Regulatory Committee

Dorset County Council

Date of Meeting	16 August 2018
Officer	Andrew Martin - Head of Highways
Subject of Report	Proposed Waiting Restrictions, Dorchester Hill/New Road, Blandford
Executive Summary	Following the advertising of proposed changes to parking restrictions in various roads in Blandford, an objection has been received to the proposals for Dorchester Hill and New Road, Blandford. This report considers the objection, and whether the proposals in Dorchester Hill and New Road should be implemented as advertised.
Impact Assessment:	Equalities Impact Assessment: The proposed waiting restrictions will have the usual exemption for disabled badge holders.
	Use of Evidence: Site investigations, public consultation and support of Local Member, Town and District Councils and the Police.
	Budget: The cost of making the Order is estimated at £2500 inclusive of advertising charges.
	Risk Assessment: Having considered the risks associated with this decision using the County Council's approved risk management methodology, the level of risk has been identified as: Current Risk: LOW Residual Risk: LOW

Appendix 1

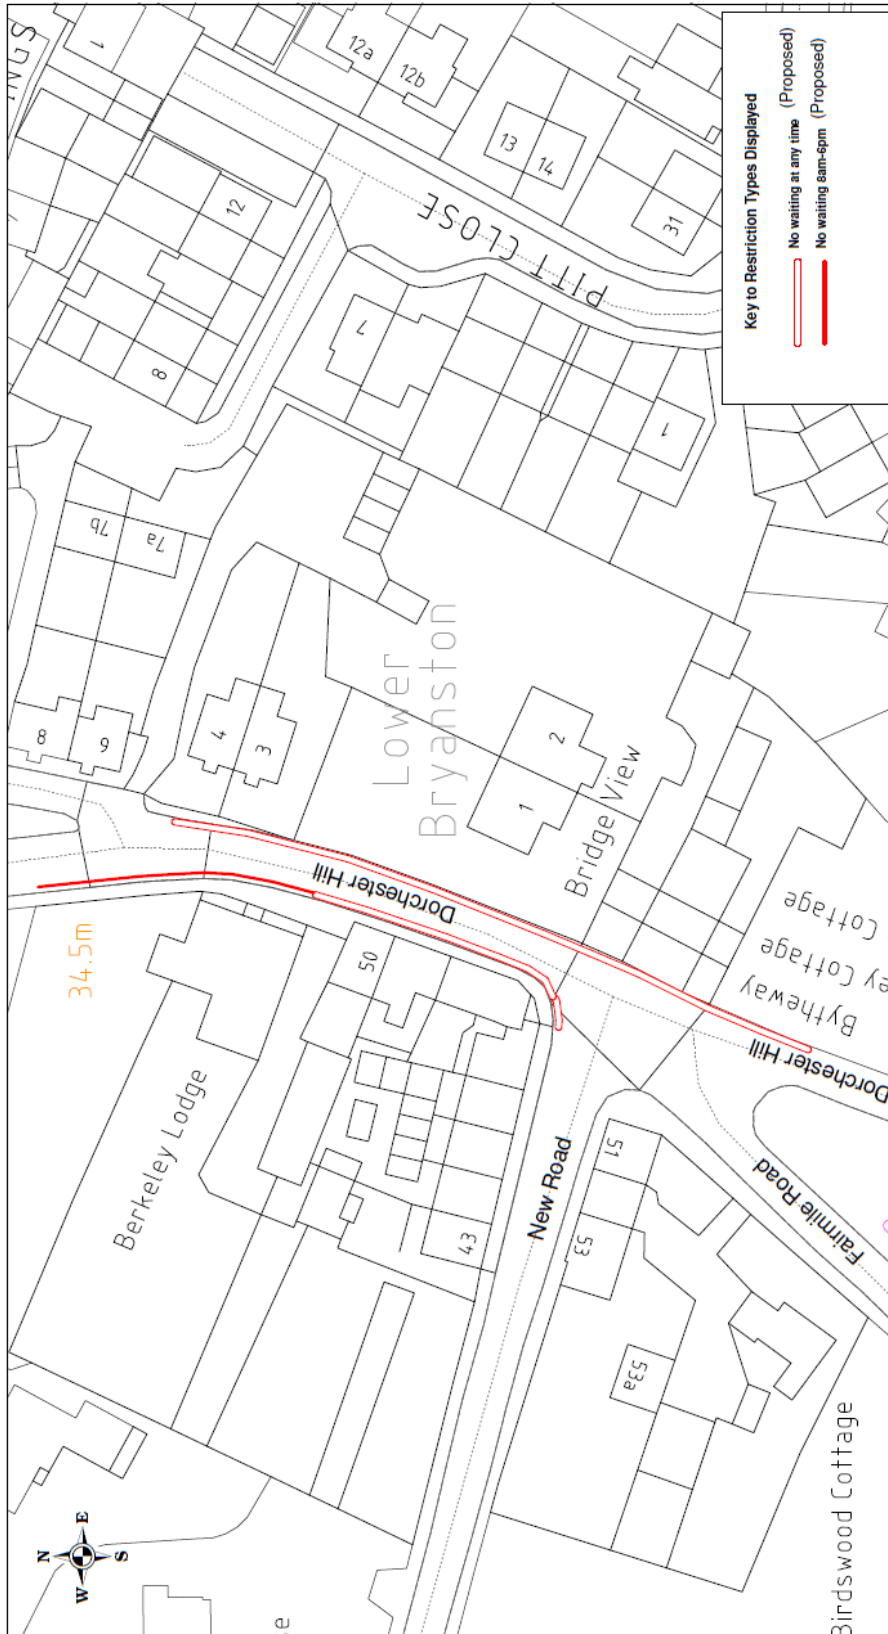
Name and Address	Summary of Response – Support of the proposal
Resident Badger Sett Blandford St Mary	The junction with New Road and the bend on Dorchester Hill is very congested with poor sight lines. Restricting parking makes huge sense for safety and traffic flow.
Name and Address	Summary of Response – Withdrawn objection
Resident Dorchester Hill Blandford St Mary	<p>Our hedgerow has been destroyed by large vehicles driving into it as they are unable to make the turn cleanly due to cars parking very close to the bend. The proposal will hopefully alleviate this problem so we are broadly supportive of it.</p> <p>Improvements to the turnings in this area could have been made by ensuring vehicles don't park near the corners rather than a blanket ban on parking along the whole stretch of road which will be unnecessarily inconvenient to some of the properties here without off-street parking.</p> <p>Concerned with the proposal as the vehicles parked in this road currently perform a natural traffic calming function. We will see an increase in speed. This is a residential area and there are many elderly residents and families with young children who live alongside this road.</p>

Name and Address	Summary of Response – Opposing the proposal
Resident Dorchester Hill Blandford St Mary	<p>The current parking on the western side of Dorchester Hill acts as traffic calming method making the unmarked dropped kerb crossing point fairly safe for pedestrians.</p> <p>The proposed will enable traffic to travel at greater speed making crossing points more dangerous to pedestrians. I propose that this crossing point be made more formal, this will only increase in importance with the increased pedestrian use of the road by the residents of the new housing development currently being built at the top of Dorchester Hill.</p> <p>There are already significant numbers of children using these crossings before and after school.</p> <p>Suggests that traffic calming methods such as sleeping policemen and/or chicanes be included such as successfully used on the Milldown Road.</p> <p>Proposes a 20 mile per hour speed limit.</p>

Name and Address	Summary of Response – Other comments
Resident Dorchester Hill Blandford St Mary	Not against this proposal, access to and from my drive will become quite a danger. There is a very restricted view up Dorchester Hill, as the pavement outside No 50 is very narrow. While cars were parked there our chance of a safe exit were good, the proposal will increase the speed of cars.

- 4.4 The proposed double yellow lines cover all the junctions that have been highlighted as problematic with visibility. As it is a short section of road it was practical to propose double yellow lines and single yellow lines from the junction of New Road to the junction of Dorchester Hill (heading towards The Stour Inn) on both sides.

- 4.5 The short stretch of the proposed single yellow lines will enable residents to park overnight and allow the free movement of traffic throughout the day. Officers are aware that parked cars sometimes perform a natural traffic calming measure. However in this instance safety for road users and improving visibility for road users and pedestrians on a fairly narrow stretch of road were important and supported by the Local Member, Dorset Police, North Dorset District Council and Blandford St Mary/Bryanston Parish Council. Any requests received have to come via the Town/Parish Council or the Local County Councillor in the first instance to be considered.

- 4.6 The objection refers to the new housing development proposed for Dorchester Hill. Having spoken with our Highway Development Team the development plans relate to further south of Dorchester Road and have initially identified the need for three pedestrian crossing points. Any future issues can be considered at the appropriate time.

- 4.7 Traffic calming methods are not considered appropriate as the road is not a 20mph zone. 20mph speed limits or 20mph zones would only be considered in streets that are primarily residential and in other town or city streets where pedestrian and cyclist movements are high, such as around schools, shops, markets, playgrounds and other areas, where motor vehicle movement is not the primary function

- 4.8 Having considered all the responses received and in particular the outstanding objection, it is considered that the current proposals should be progressed rather than leave the situation as existing.
